**Walden Lake Site Plan Changes since the Planning  
Board meeting  
Corresponds with clouded version of PD site plan**

WALDEN LAKE PLANNED DEVELOPMENT DISTRICT  
CITY OF PLANT CITY  
WALDEN LAKE, LLC FL

Project No.:	0188-001
Issued:	05/15/2023
Drawn By:	MAS
Checked By:	IA
Scale:	1" = 300'
Sheet Title:	PLANNED DEVELOPMENT SITE PLAN
Sheet Number:	2 of 3

Project No.	0188-001
Issued:	05/15/2023
Drawn By:	MAS
Checked By:	IA
Scale:	1" = 300'
Sheet Title	MASTER RECREATION AND OPEN SPACE PLAN
Sheet Number	3 of 3

**Sheet 3 of 3**

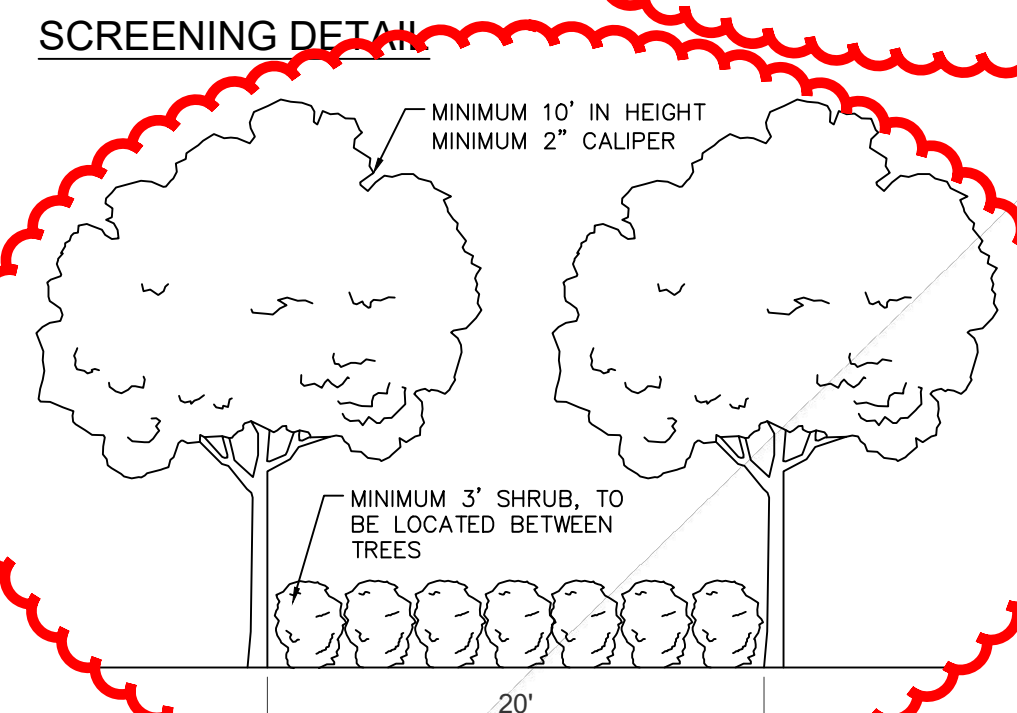
24. Revised to remove the roundabout shown on Sheet 3 of 3 adjacent to the CSX railroad to match the roadway design shown on Sheet 2 of 3.
25. Revised POD 62 layout to match Sheet 2 of 3.
26. Split POD 70 into POD 70A and POD 70B to match sheet 2 of 3.
